Date: **February 7, 2000**

Model: **PVM-1942Q, PVM-1943MD, PVM-1944Q
 PVM-2042QM, PVM-2043MD, PVM-2044QM**

Subject: **CORRECTING ARC BETWEEN TRACES**

Figure 1

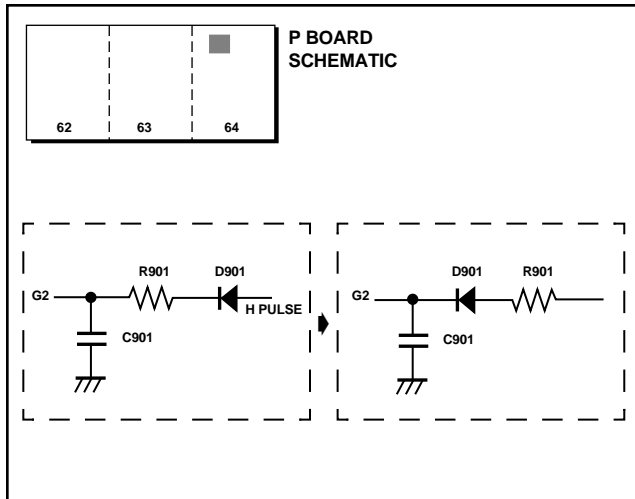
An arc may occur between trace of cathode on diode D901 and trace from collector of H OUT transistor on the P board (side A), possibly damaging the board.

To correct this condition during repair or maintenance, exchange the locations of D901 and resistor R901 as shown in Figure 1.

NOTE: To prevent possible board damage, implement this correction *before* symptom occurs.
